Subject: MAO - FW: DC-19-1010-RM

Subject: DC-19-1010-RM

Comments by Haverhill Town Council's Planning Committee dated 11th June 2019 included:

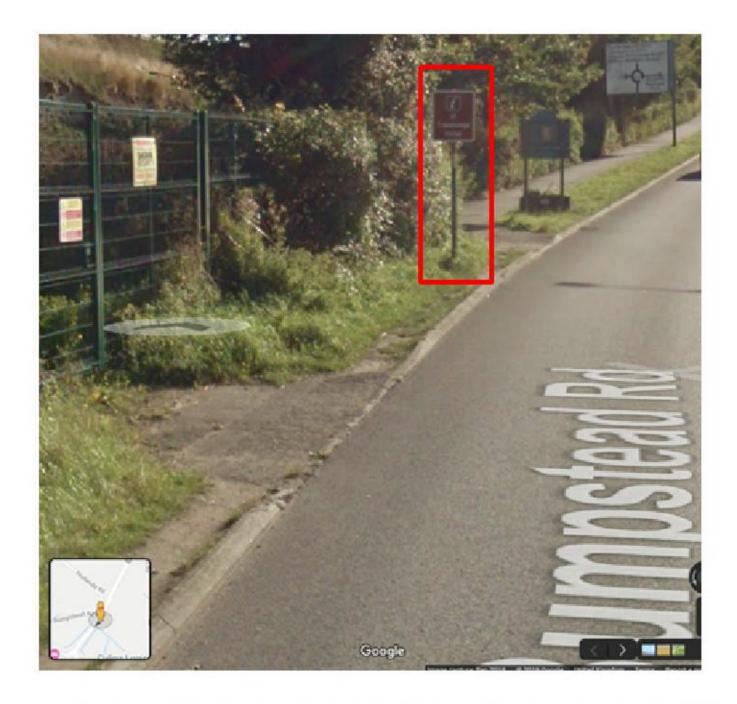
The only proposal from the applicant for a footpath is "Section 278 works to extend and link existing footpath (approx 50.0m)" adjacent to the N corner of the site. Although the existing mapping on https://highwaysreporting.suffolk.gov.uk shows this as surfaced footpath, it is a trampled track along a verge that is overgrown in places

and is obstructed by this brown sign just N of the Haverhill boundary sign

so that the trampled track, which is inevitably muddy when wet, is very close to the kerb.

The following extract from mapping on https://highwaysreporting.suffolk.gov.uk shows the applicant's proposal as a blue line and missing surfaced footpath as three segments of red line:

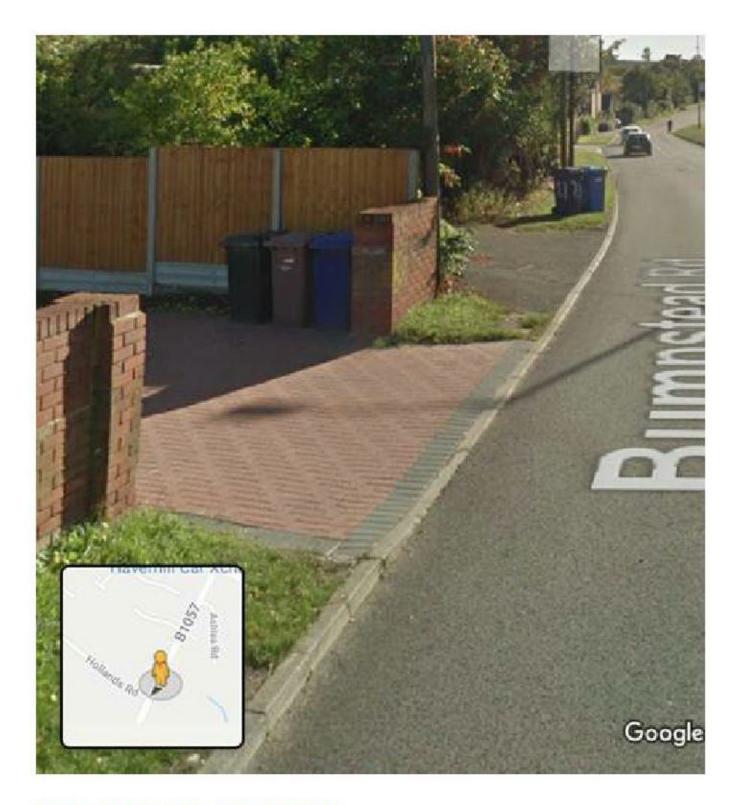
After reviewing the existing provision on mapping and Google Street View, I don't think continuous footway on the SE side of Bumpstead Road from the development "to at least Hollands Road" is sufficient for pedestrians wanting to connect to and from E of the junction of Bumpstead Road with Sturmer Road. For safe access, they need surfaced footpath all the way to 15 Bumpstead Road, just S of Ashlea Close.

The applicant's proposal is therefore very welcome, but it still leaves a lot to be done to protect pedestrians from hazard.

From outside 19 Bumpstead Road:

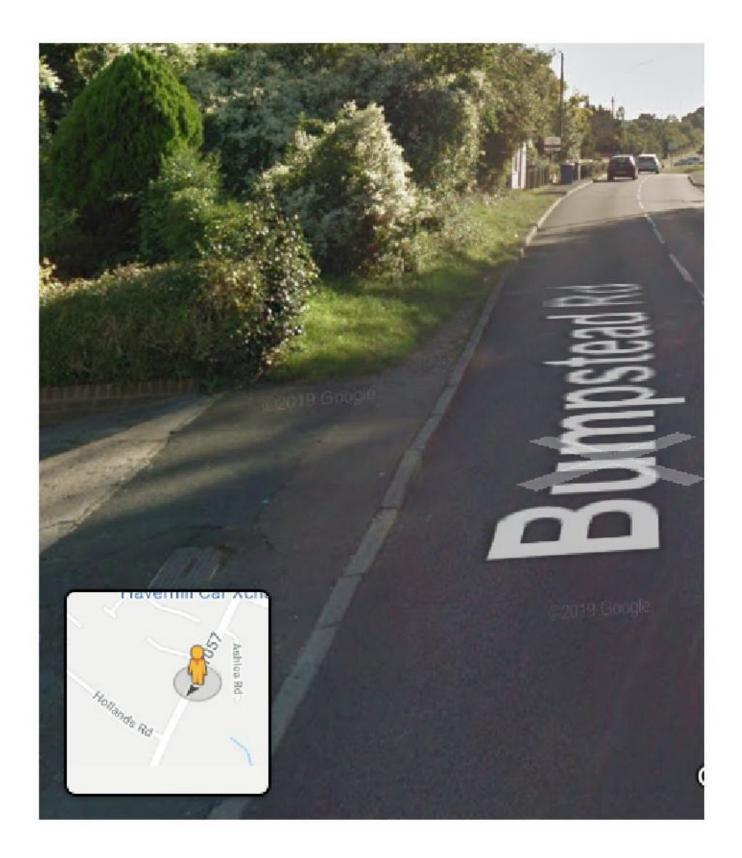
The following sequence of screenshots from Google Street View, looking SSW, starts from the S and progresses backwards NNE, to make it easier to interpret the photos:
